SUBJECT: ST. LUCIE UNIT 1 - ISSUANCE OF AMENDMENT RE: BORIC ACID MAKEUP SYSTEM (TAC NO. 67051)

FLORIDA POWER & LIGHT COMPANY  
DOCKET NO. 50-335  
ST. LUCIE PLANT UNIT NO. 1  
AMENDMENT TO FACILITY OPERATING LICENSE

Amendment No. 94  
License No. DPR-67

SAFETY EVALUATION BY THE OFFICE OF NUCLEAR REACTOR REGULATION

# FIGURE 3.1-1 ST.LUCIE 1 MIN BAMT VOLUME

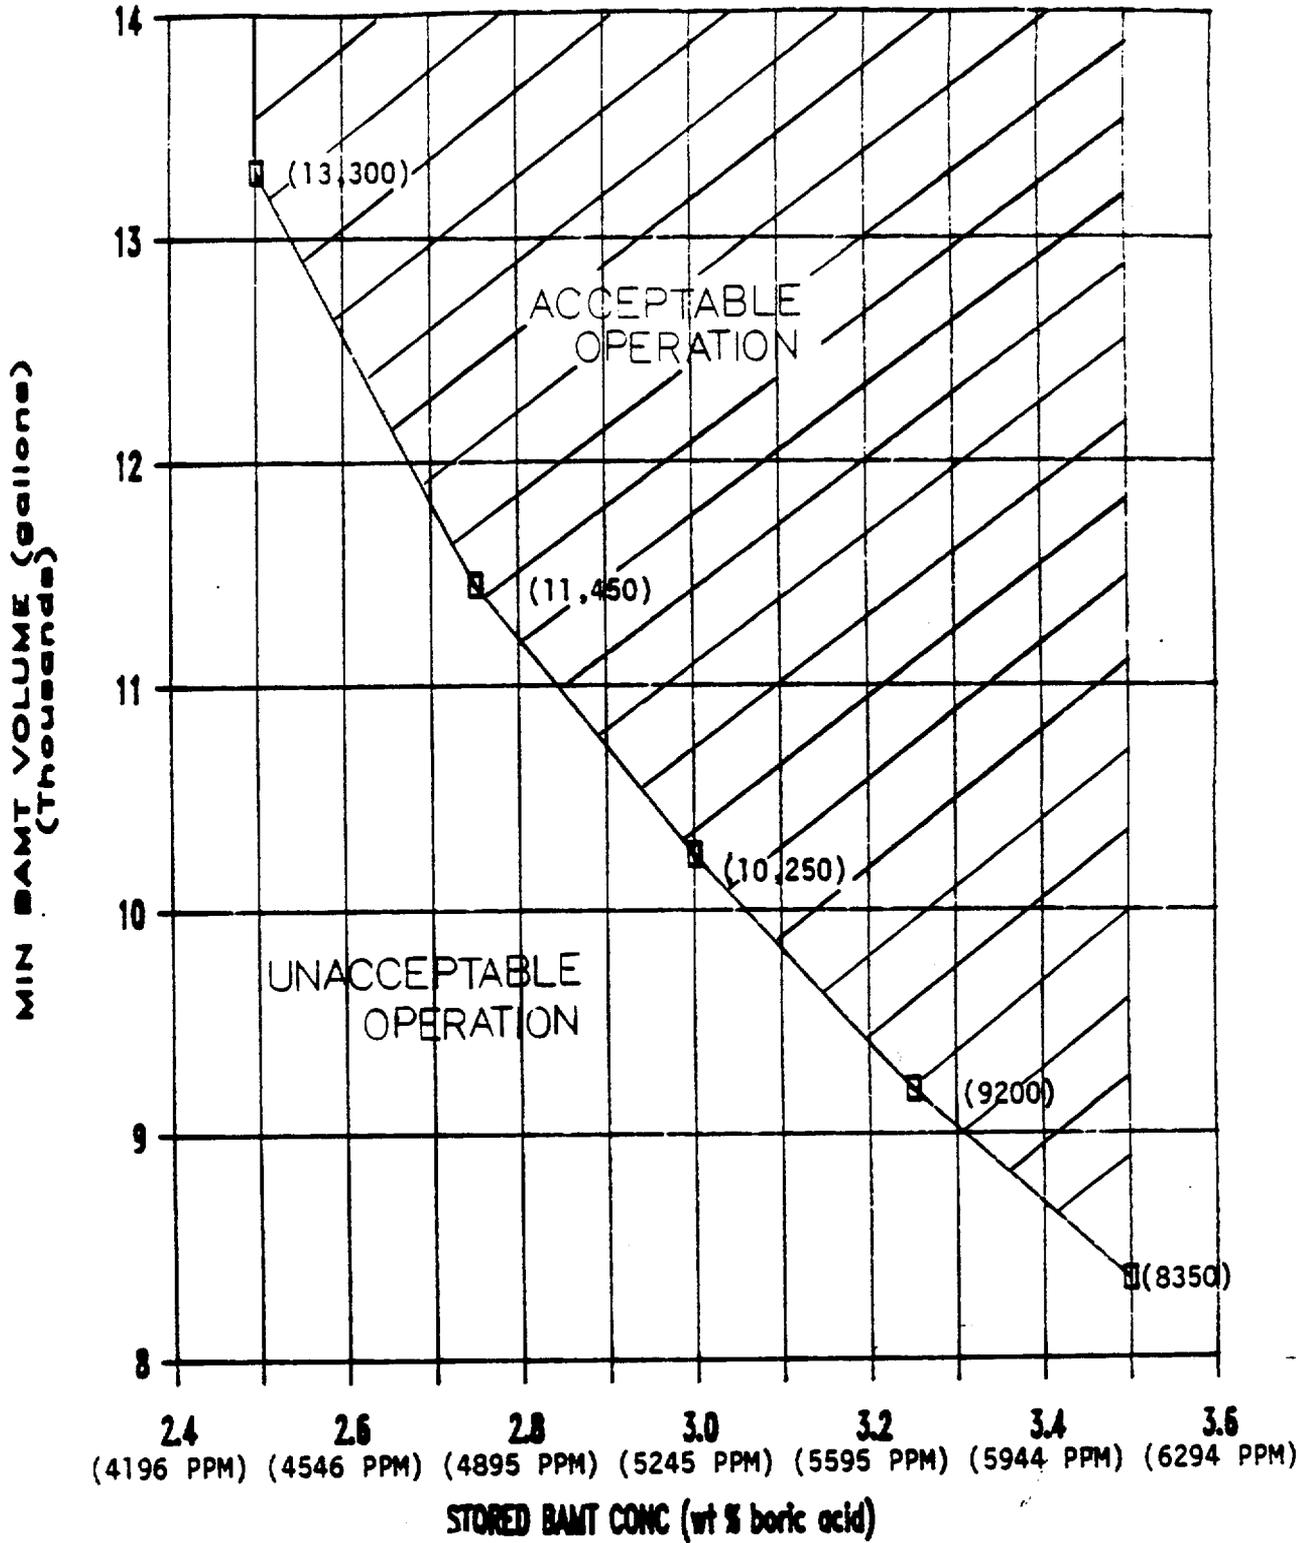
#### Figure 3.1-1 (for Operating Modes 1 through 4)

The existing figure specifies the minimum required BAMU water volume and temperature as a function of stored boric acid concentration for the various plant operating modes. The existing figure is applicable to any one of the two BAMU tanks, each having a maximum capacity of 9700 gallons (only 9450 gallons assumed to be useable). The revised figure specifies the minimum required water volume (contained in one or both BAMU tanks) as a function of boric acid concentration in the BAMU tank. This curve was generated in report CEN-353(F) for a minimum refueling water tank boron concentration of 1720 ppm boron. This curve conservatively bounds BAMU tank minimum required water volumes for conditions when the refueling water tank boron concentration is greater than 1720 ppm (a Technical Specification requirement). The range of

boron concentration in the BAMU tank will be reduced from 8.0 to 12.0 weight percent boric acid to 2.5 to 3.5 weight percent. The upper range of the required borated water volume will increase from 7,900 gallons (8 weight percent) to 13,300 gallons (2.5 weight percent). The lower range of the required borated water volume will increase from 6,600 gallons (12 weight percent) to 8,350 gallons (3.5 weight percent). The revised Figure 3.1-1 is consistent with the analytical results of CEN-353(F) for plant conditions at Operating Modes 1 through 4 to maintain the required safe shutdown margin. The temperature versus BAMT concentration curve has been removed from the Technical Specifications since it is no longer required. The revised figure is acceptable.
